### Remarks

In view of the above amendment and the following remarks, favorable reconsideration of the outstanding office action is respectfully requested. Claims 1 – 6 remain in this application.

**VERSION WITH MARKINGS TO SHOW CHANGES MADE**

FIG. 2

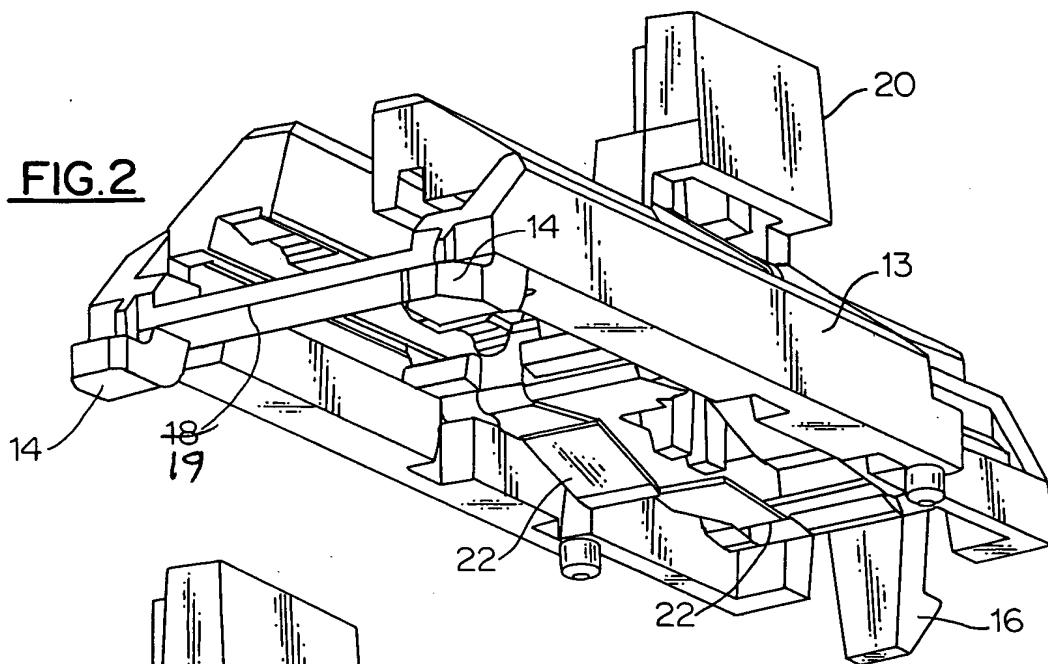
A copy of sheet 2 of the formal drawings, previously filed in this application, is submitted with this Response. This sheet includes proposed revisions marked in red for the Examiner's review and approval. In paragraph 1 of the outstanding office action the Examiner pointed out that in Figure 2, reference numeral "18" should be changed to reference numeral "19." The proposed revision is made in accordance with the Examiner's comments.
